ADDENDUM

Date Issued:	February 18, 2022
Project:	Intermountain Healthcare Linear Accelerator Replacement at LDS Hospital 8 th Avenue, C Street Salt Lake City, Utah 84143
Addendum Number:	1

**Intermountain Healthcare
Linear Accelerator Replacement at
LDS Hospital**

Interior Elevations

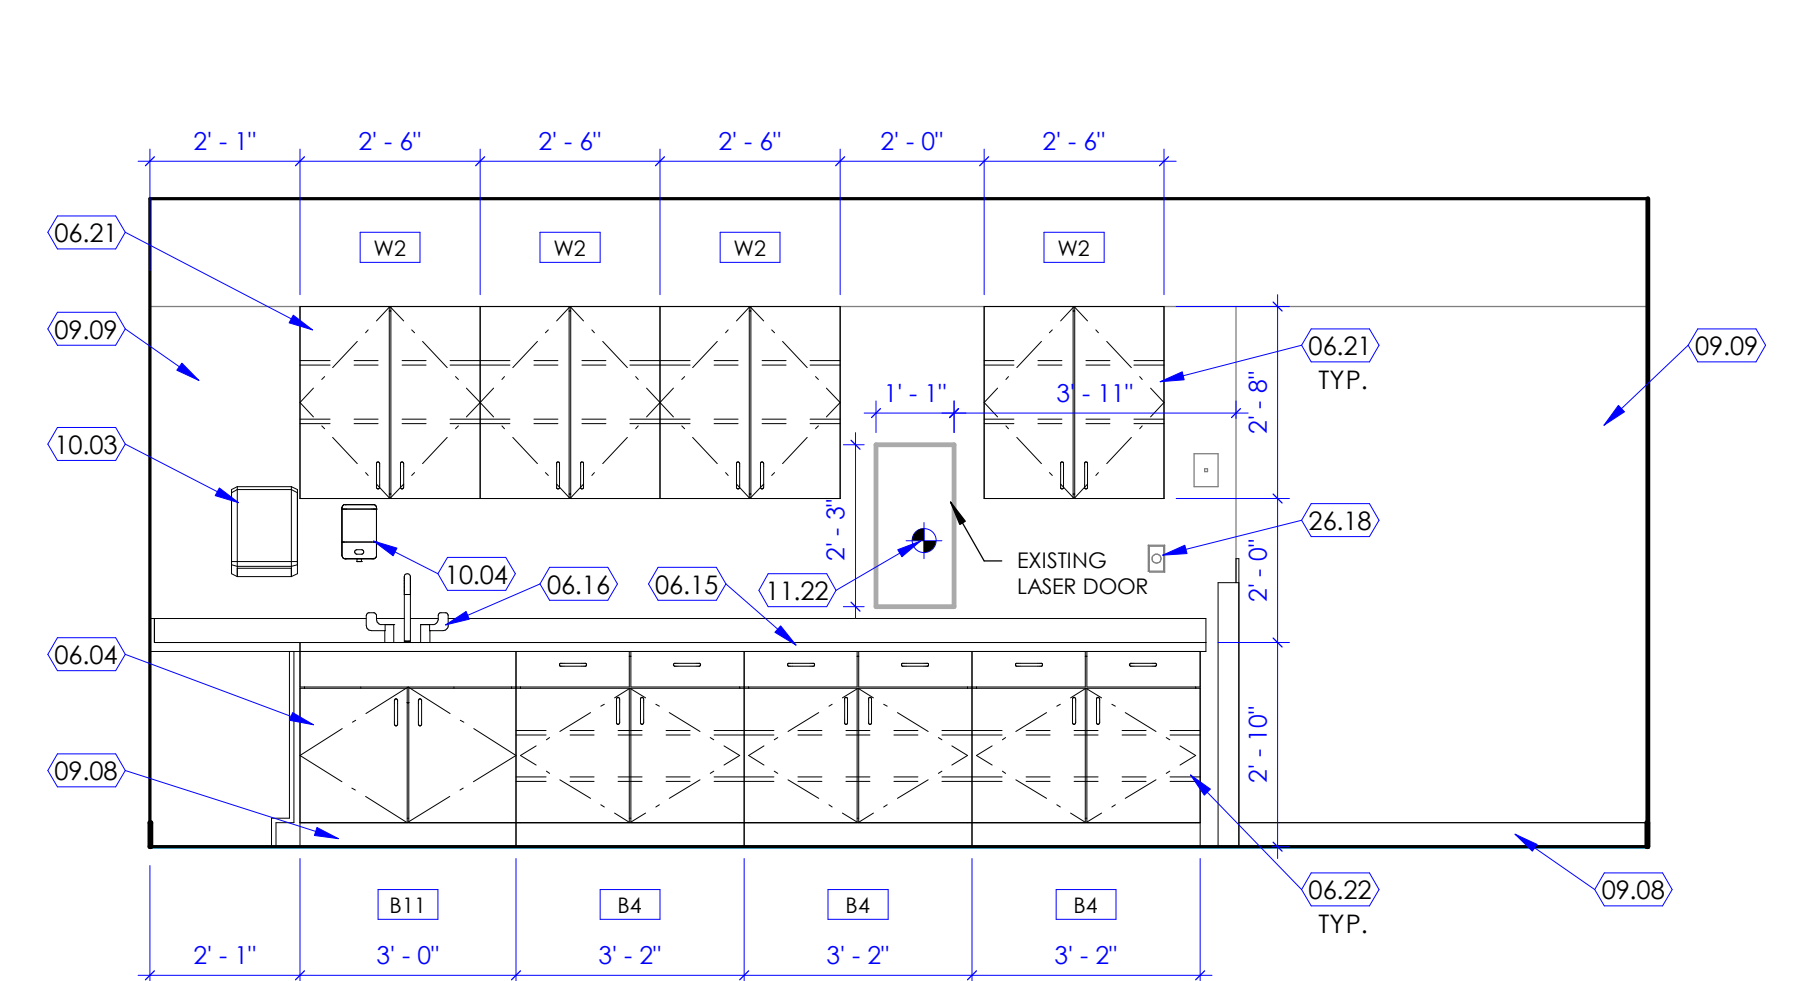
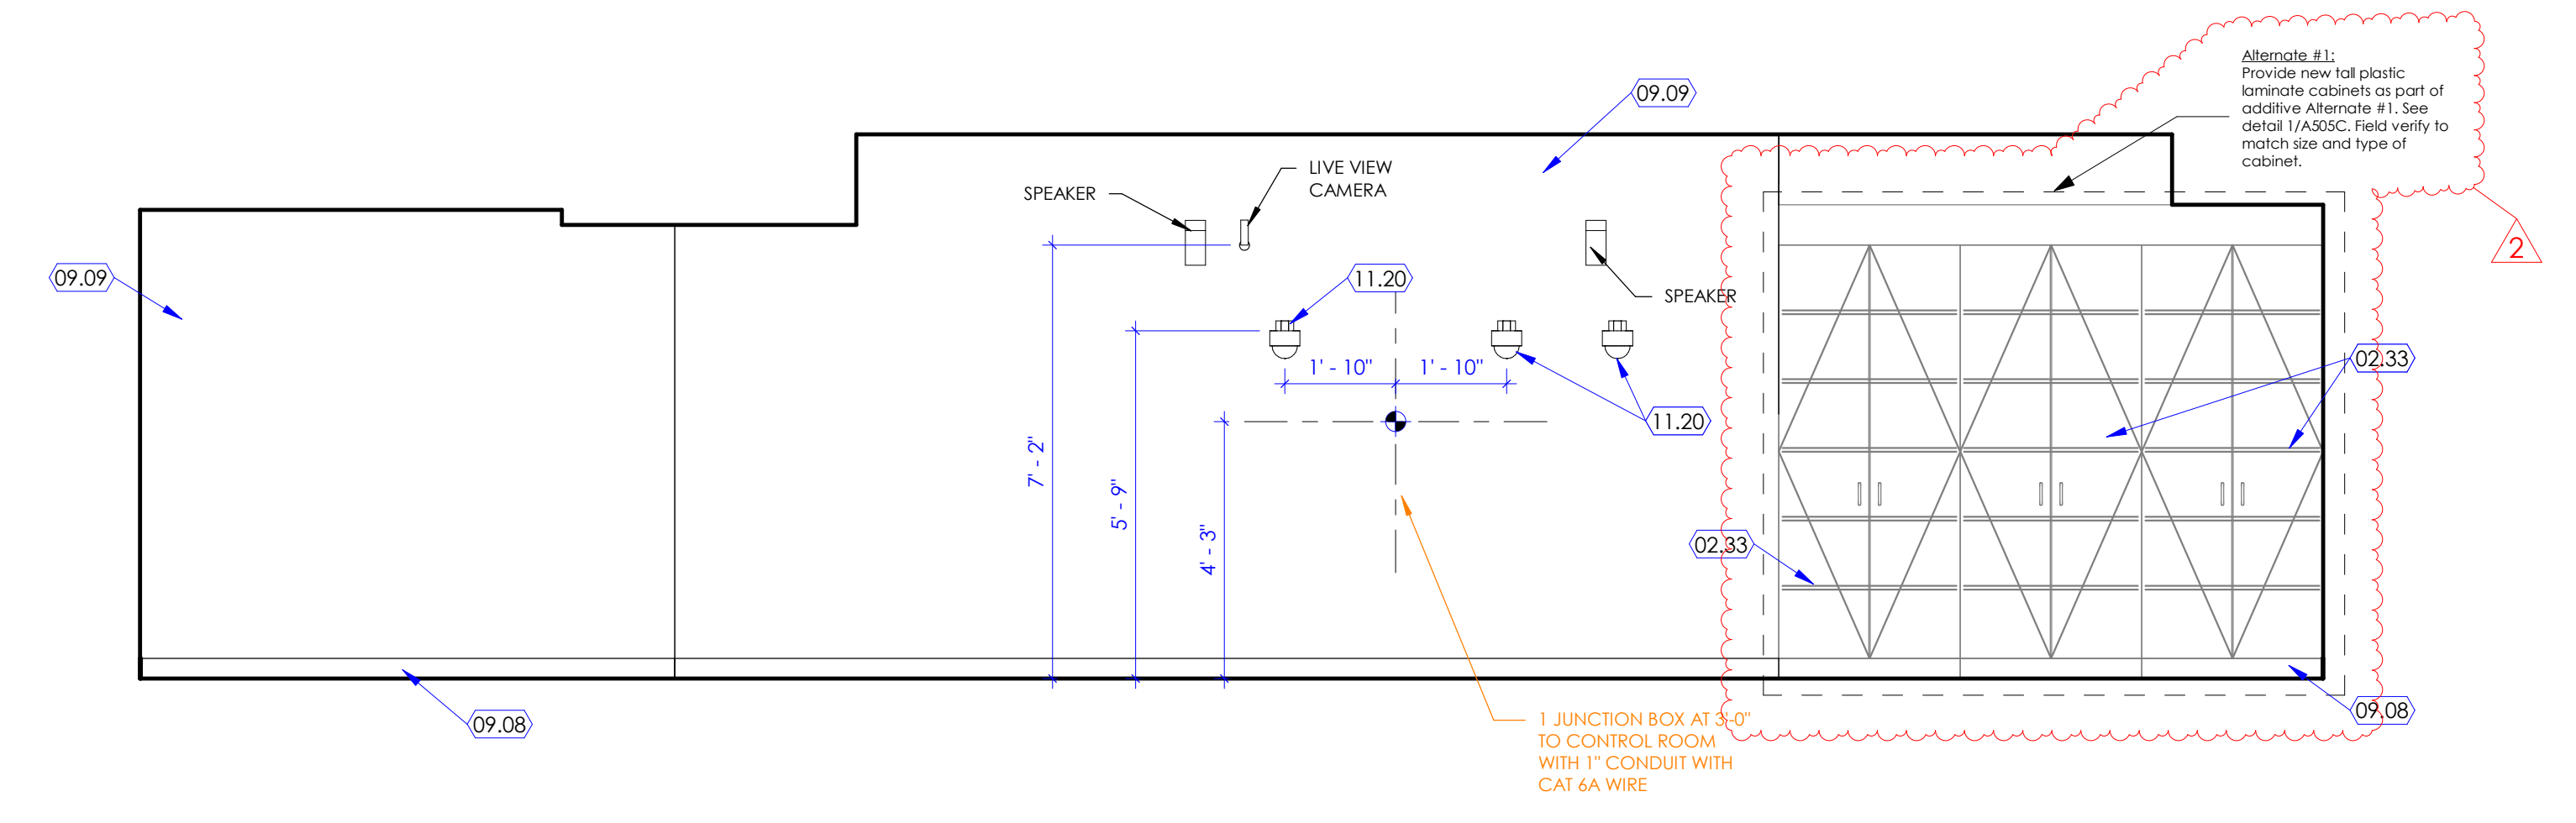
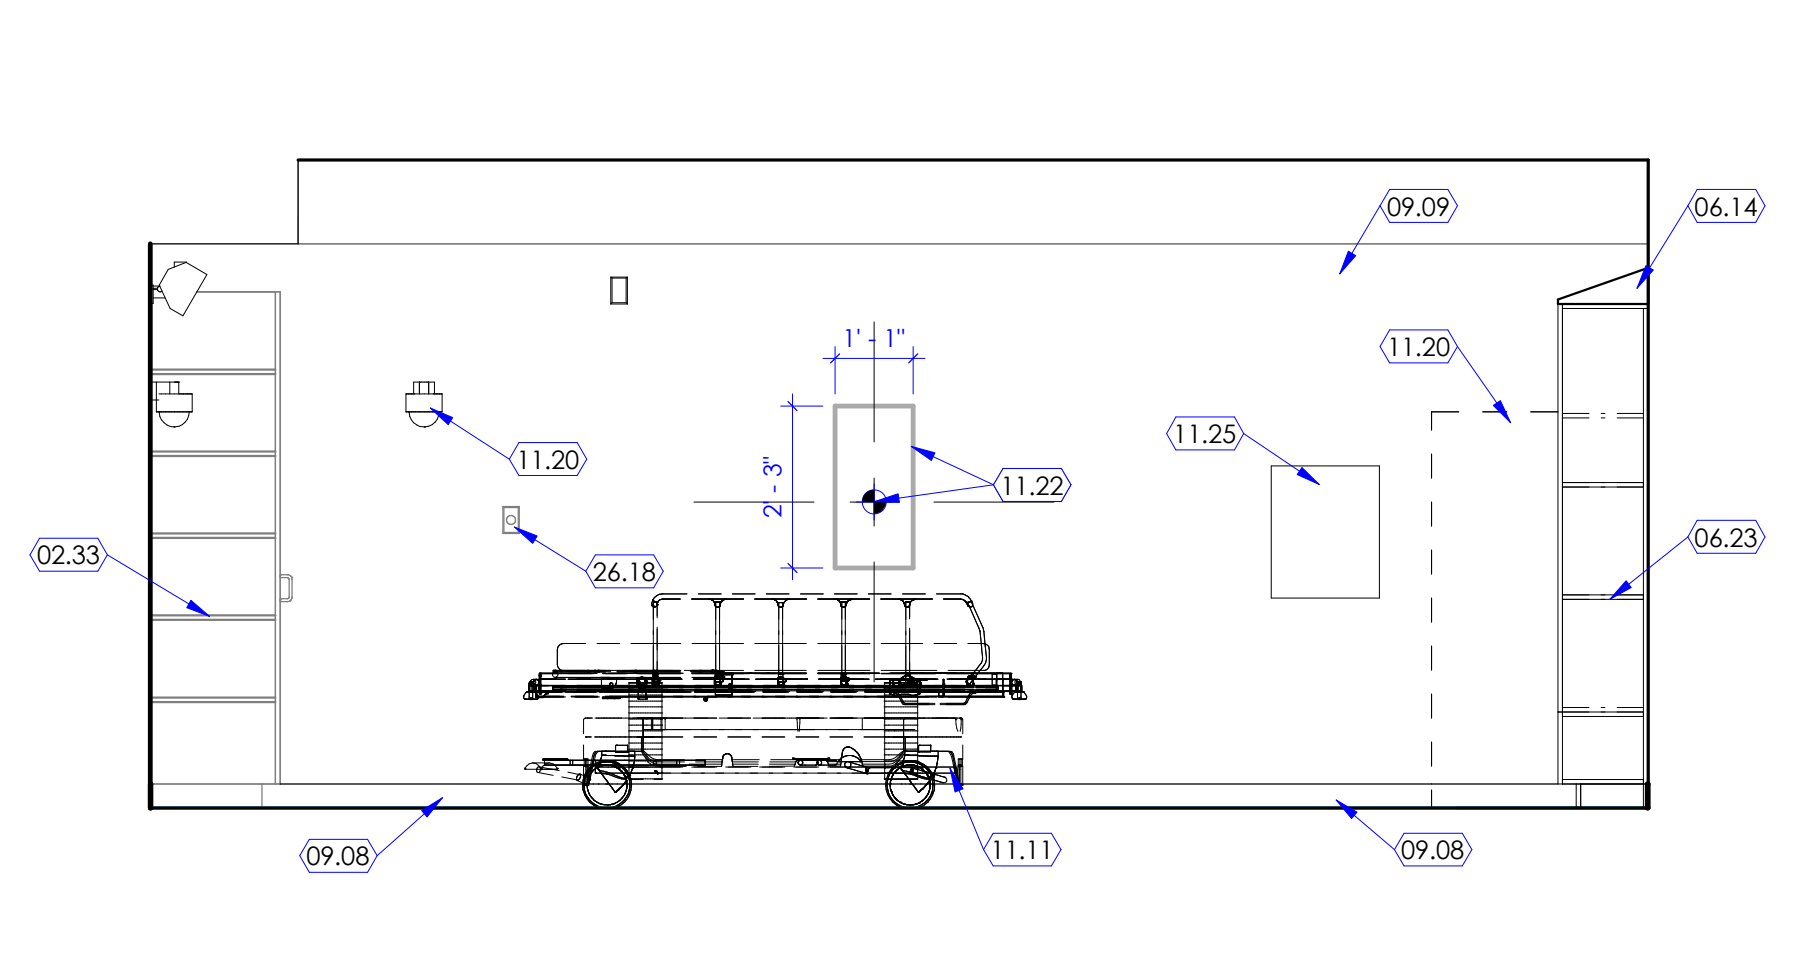
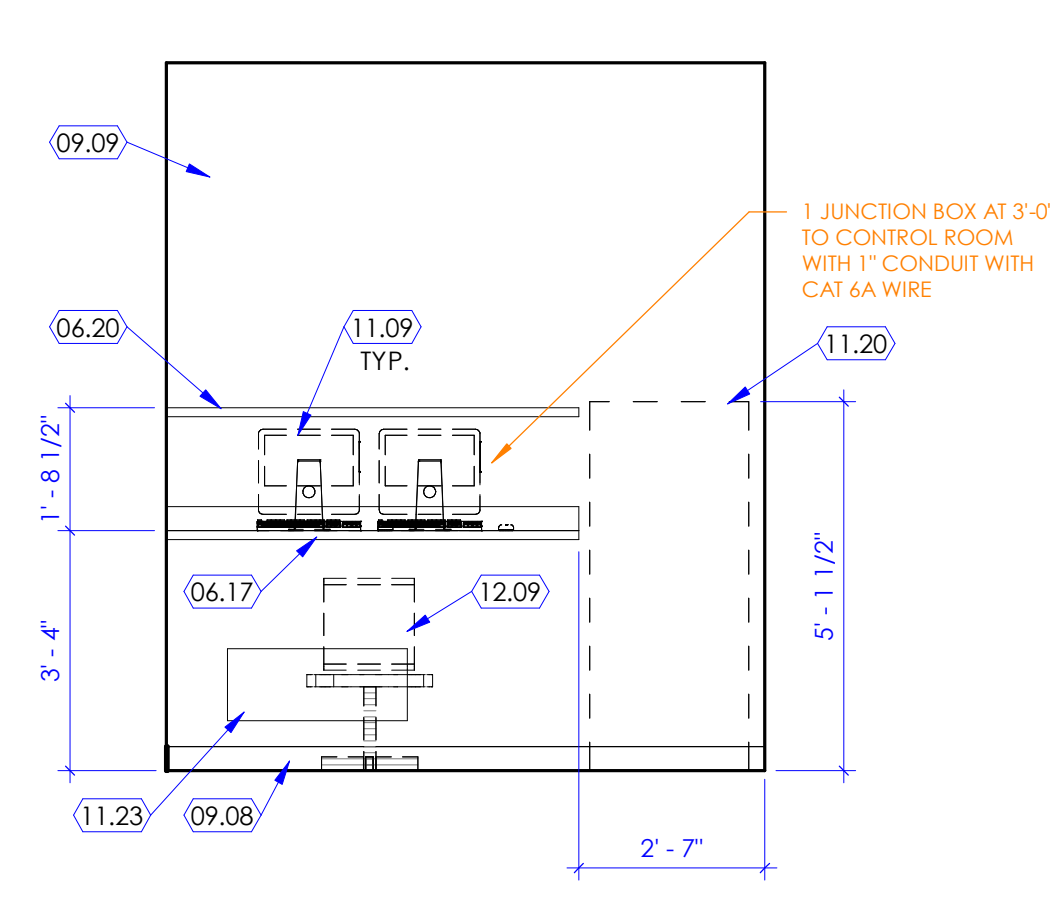
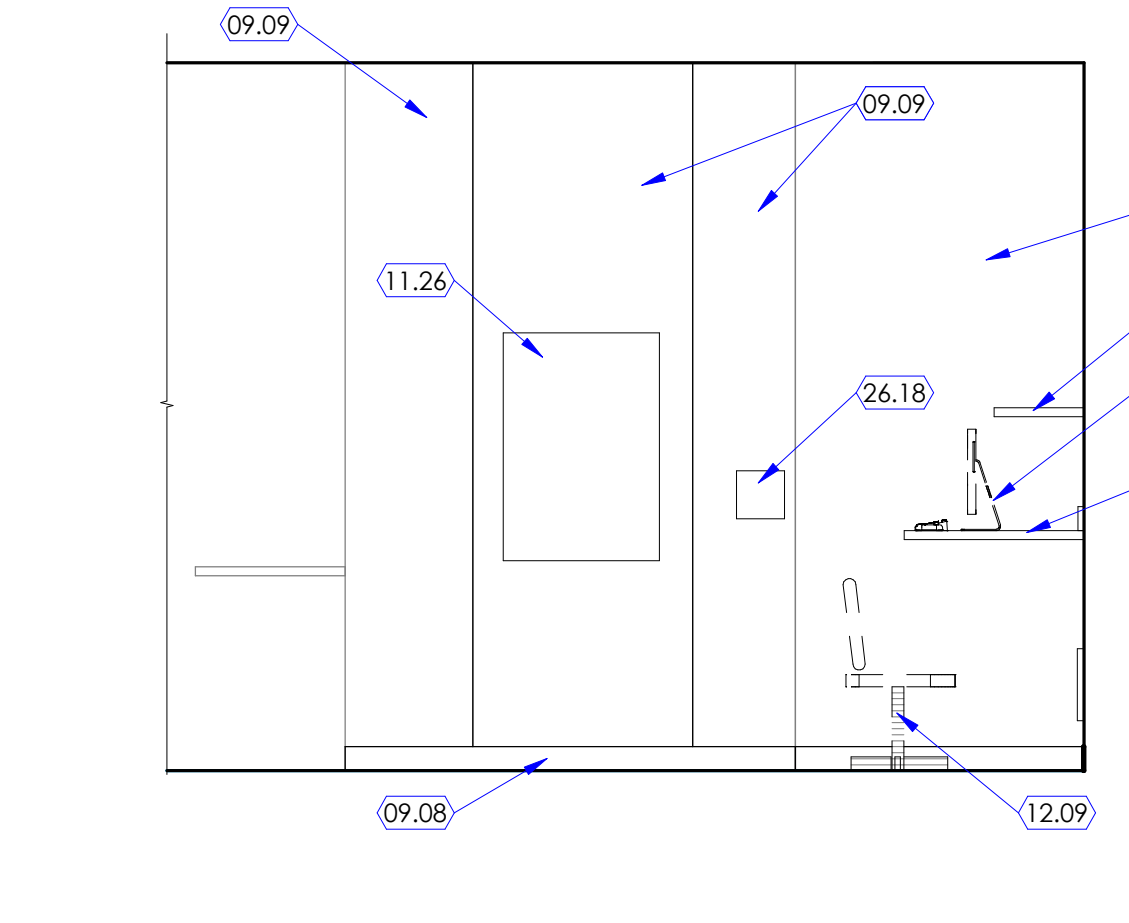
Sheet Number	Drawings
A251	See attached sheet with revision shown clouded.
